City of Portland, Maine – Building or Use Permit Application 389 Congress Street, 04101, Tel: (207) 874-8703, FAX: 874-8716

BUILDING PERMIT REPORT

DATE: 12 July 2000 ADDRESS: 38 Lower A St. P.I CBL: 08744-026

REASON FOR PERMIT: Interior renovations

PLOT PLAN

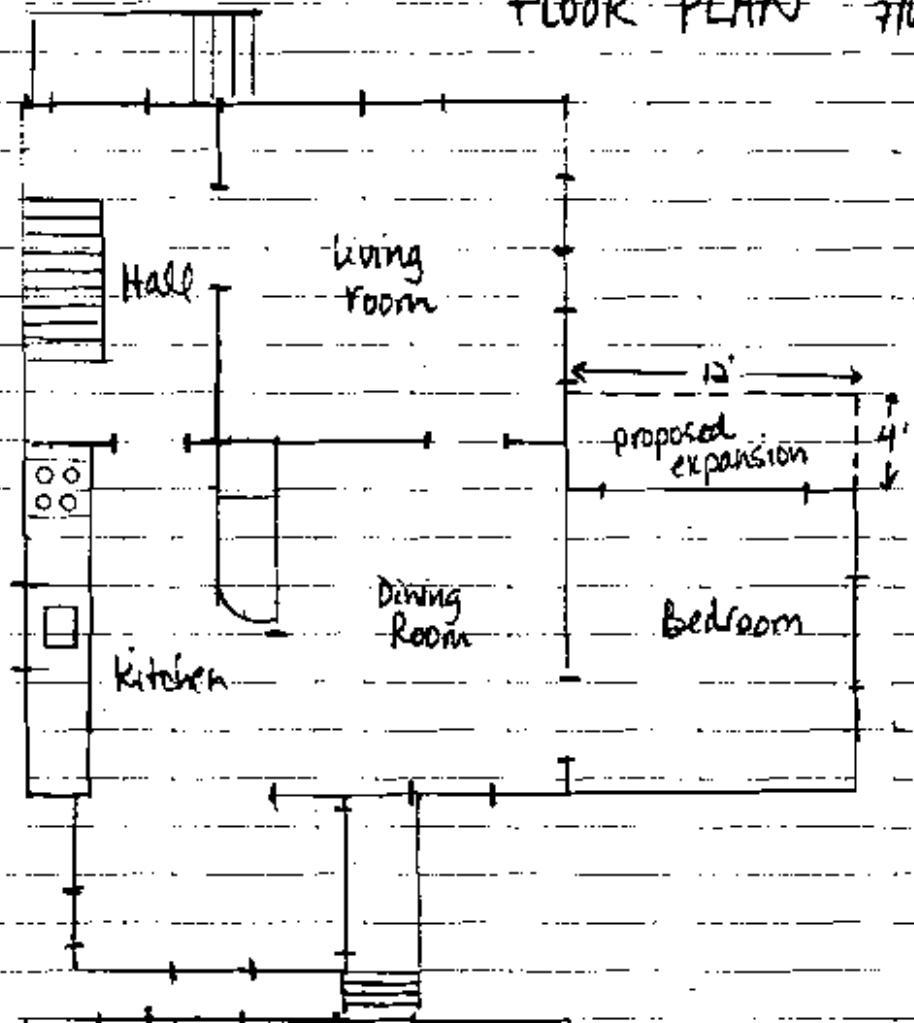
Front yard - 14.5' req - 18' scaled
side yard - 20' req - 25' shown
rear yard - 25' req - 40' shown

front setback can be averaged
4' scaled
25' req
 $\frac{29 + 2}{2} = 14.5'$ min req

ADDITION FOUNDATION

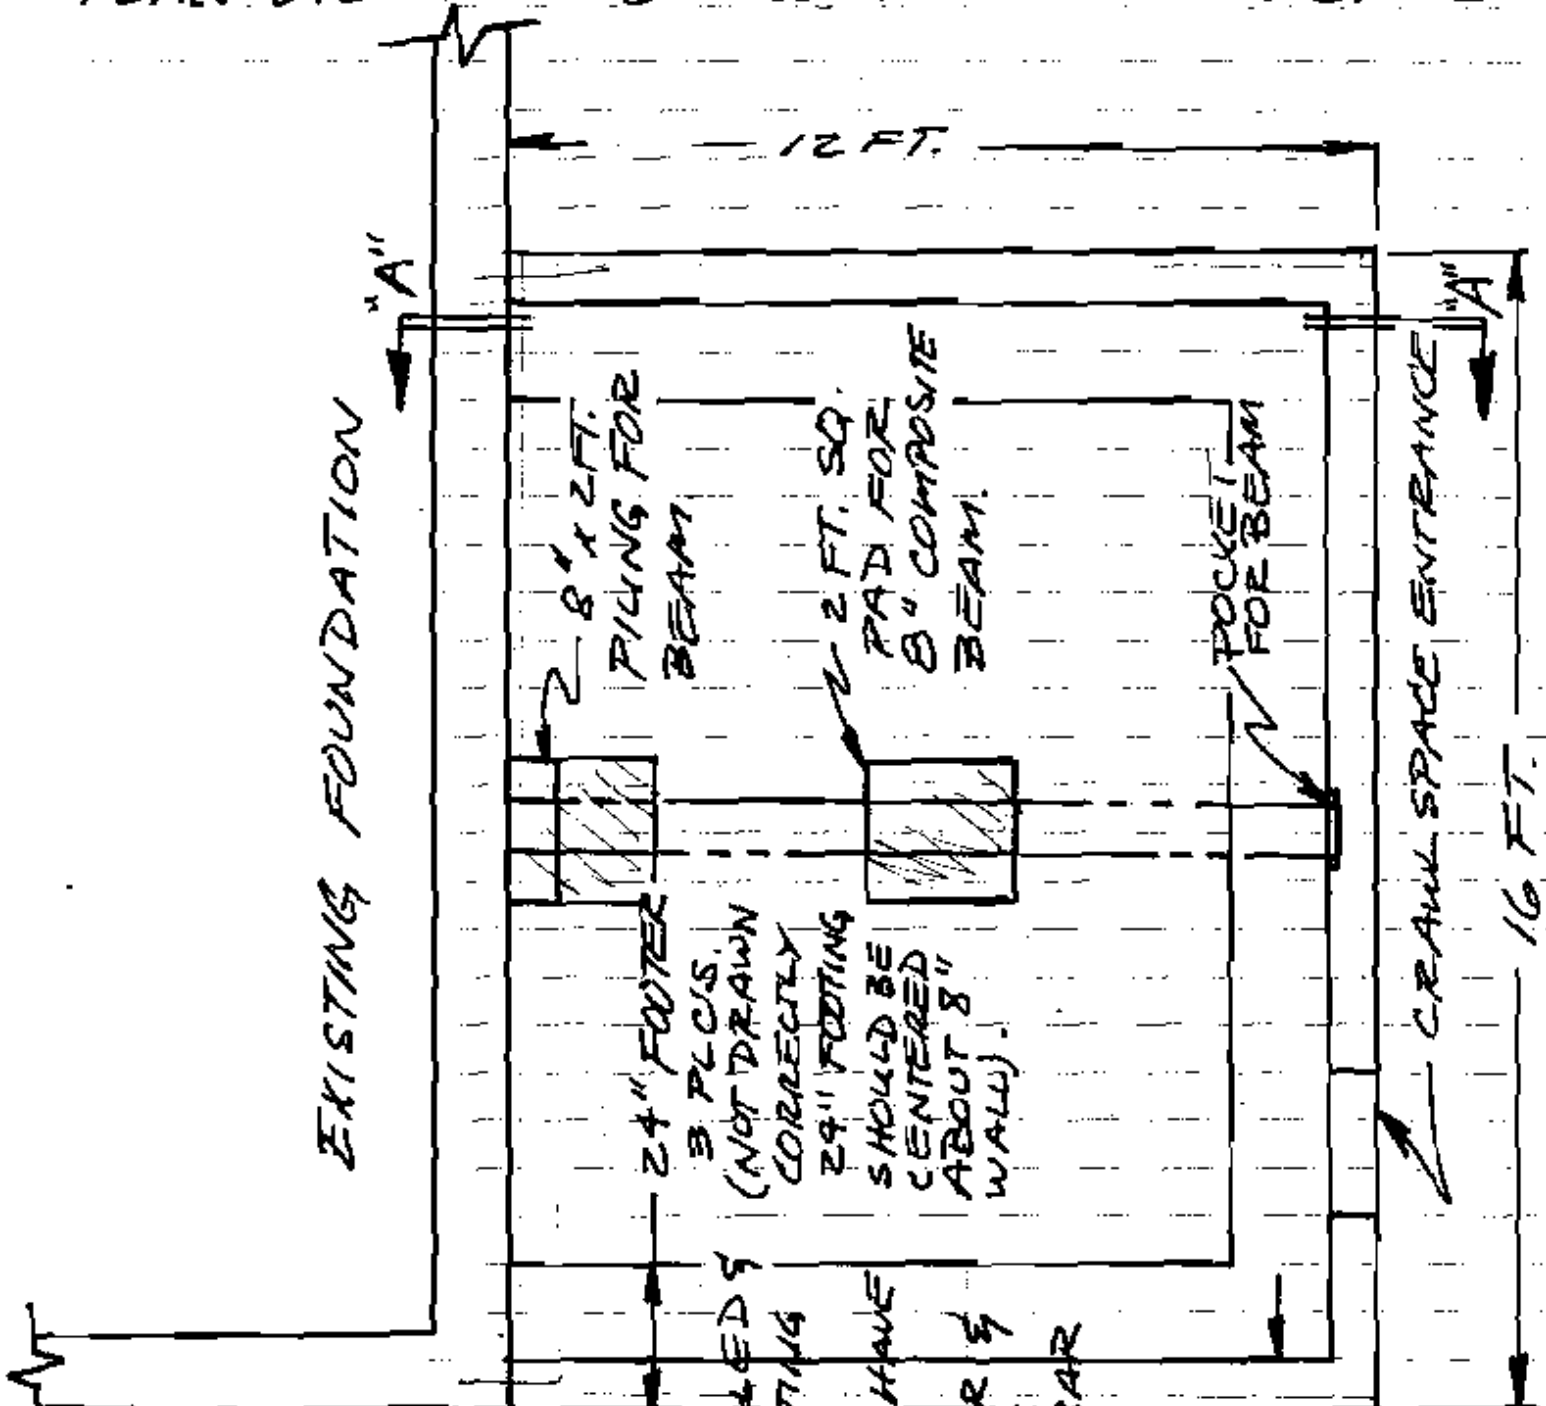
11-1-00 checked footing - foundation is to be pinned went over plans. OK. to proceed GR

24" FOOTER 3 P.C.'S. (NOT DRAWN CORRECTLY)
29" FOOTING SHOULD BE CENTERED ABOUT 8" WALL.
